DESCRIPTION:
Ltr re our 3-20-74, furnishing addl info concerning control rod drive conversion programs at Nine Mile Point #1

PLANT NAME: Nine Mile Point Unit #1

Re: Provisional Operating License: DPR-17
Docket No: 50-220

FIG 1

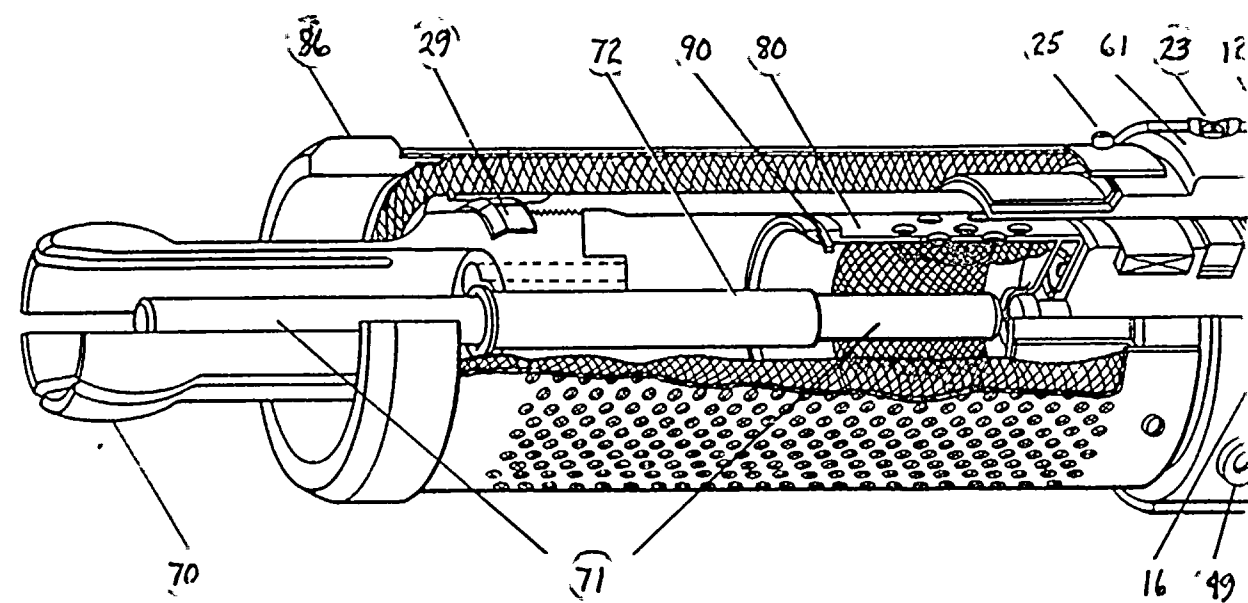
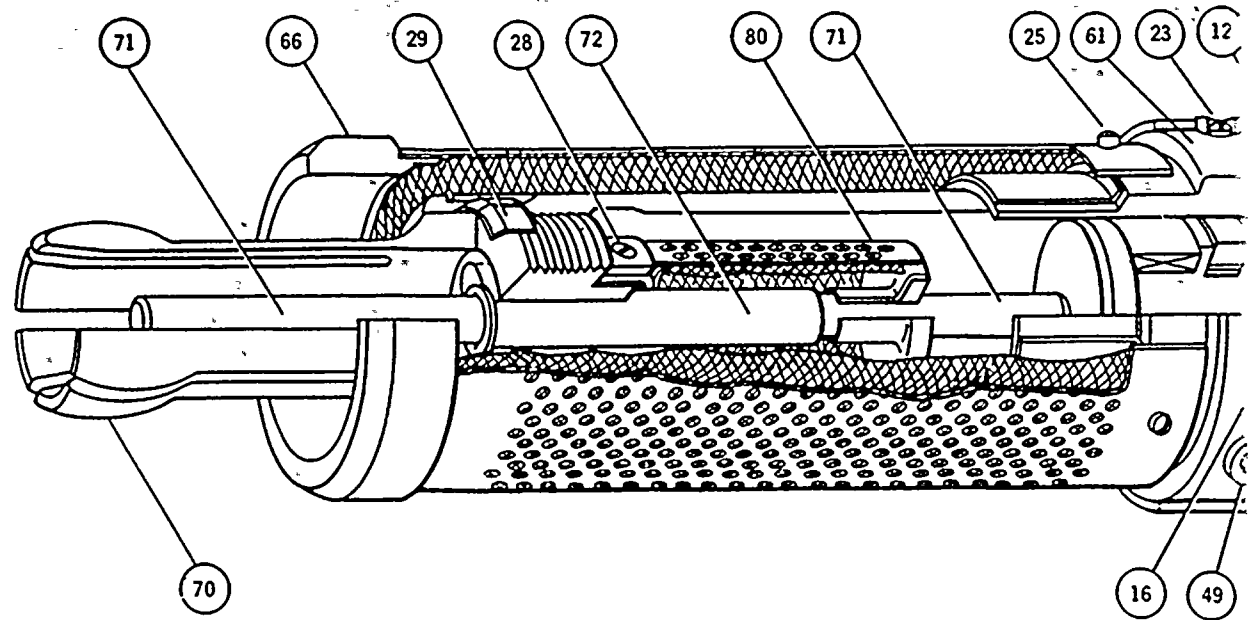
1. The proposed conversion program consists of the repositioning of a filter to place this filter in the flow path for reactor water to the stop piston seals and not in the scram path. (Figure 1) The fine mesh filter was originally mounted on the traveling portion of the drive and early in plant life, prior to changing the mesh size, was responsible for deteriorating scram times. However, with the repositioning, the filter is mounted on top of the stop piston and is provided to filter reactor water flowing to the stop piston seals, removing foreign particles or abrasives matter that could result in internal damage to the seals. This modification has been recommended by General Electric Company, the nuclear steam supplier, and is the design incorporated on later plants¹. Based upon testing results of all control rod drives, criteria has been established in determining the scheduled modification of all control rod drives. A withdrawal stall leakage flow test was performed on all control rod drives.
